HORSESHOE COVE, FLA.

PRELIMINARY
404(b) EVALUATION REPORT
HORSESHOE COVE
DIXIE COUNTY, FLORIDA
CONFINED UPLAND DISPOSAL SITE

Re: U.S. Army Corps of Engineers
 Public Notice No. PN-HC-178,
 Dixie County, Channel
 Maintenance Dredging,
 Horseshoe Cove

TYPICAL DREDGING SECTION
 (CROSS SECTION C-C, TURNING BASIN,
 STATION 187+00)

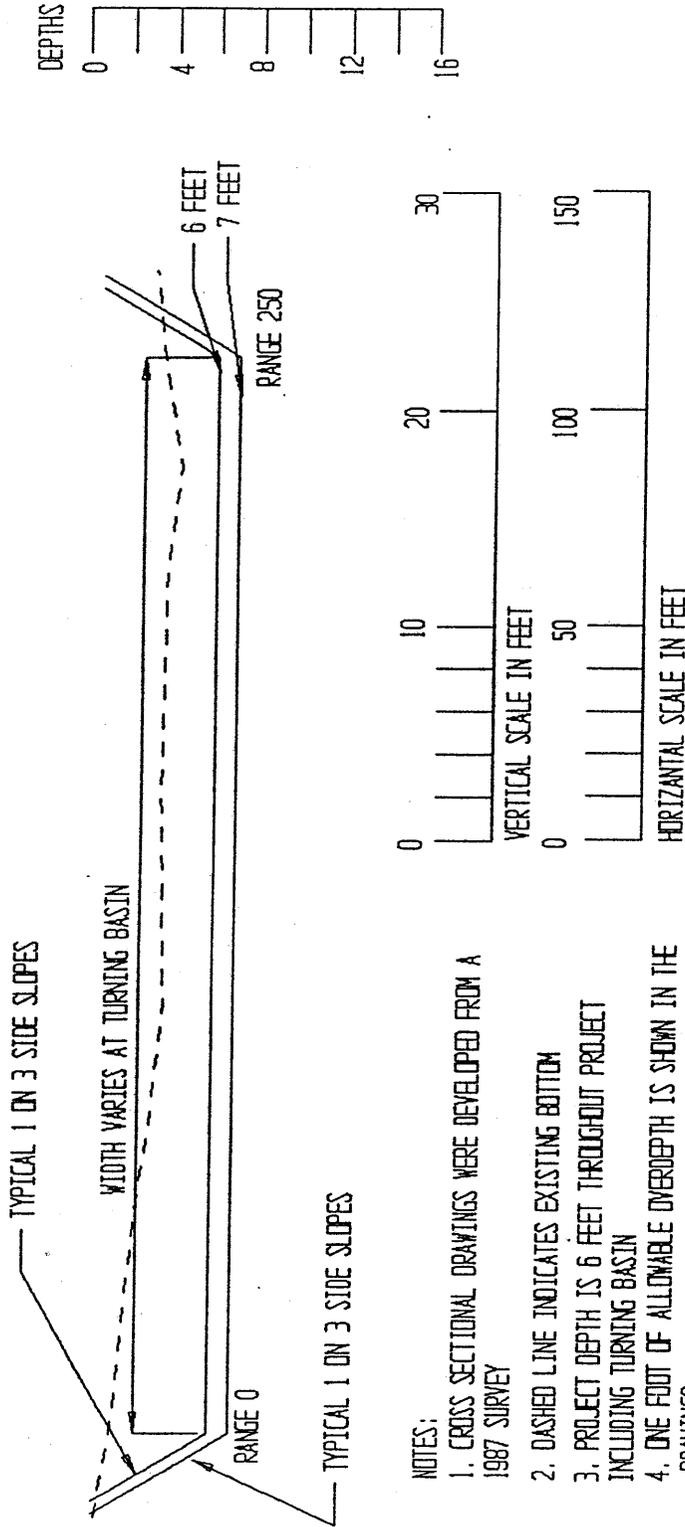
1. A field survey of the channel and turning basin should be made to determine if seagrass beds are present within the project boundaries. If seagrasses are found within the large turning basin, the applicant should consider modifying the proposed shape of the basin and amount of dredging to avoid impacts to this important marine community.
